ADDENDUM NO. 1

PROJECT NO. TMUA-W 23-09 TO-01 – SPAVINAW PUMP HOUSE

**ADDENDUM NO. 1  
TO  
PROJECT NO. TMUA-W 23-09 TO-01 – SPAVINAW PUMP HOUSE**

**ADDENDUM NO. 01**  
**Spavinaw Pump House**  
**TMUA-W 23-09 TO-01**  
January 8, 2025

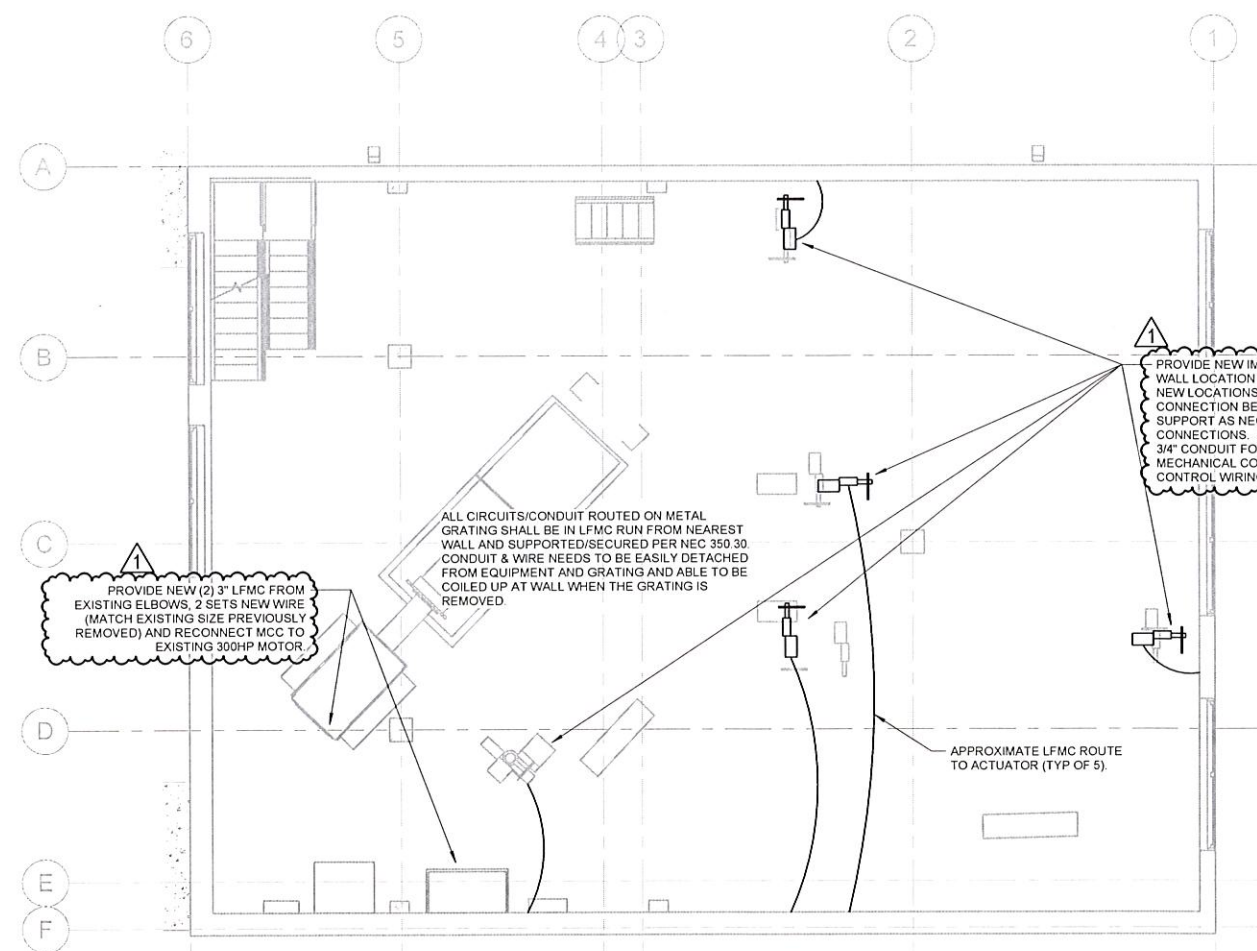
9. E2-01
  - i. Added boxed note about bonding floor grating.
  - ii. Detail 1
    - i. Modified note about floor mounted equipment including information for steel plate and bracing.

- iii. Detail 2
    - i. Added note for new wire & conduit for 300HP pump.
    - ii. Modified note for valve actuators to include wire sizing.

1 ENSURE NEW METAL FLOOR GRATING IS PROPERLY BONDED TO ELECTRICAL SYSTEM TO ENSURE NO POTENTIAL EXISTS BETWEEN GRATING AND ELECTRICAL EQUIPMENT.
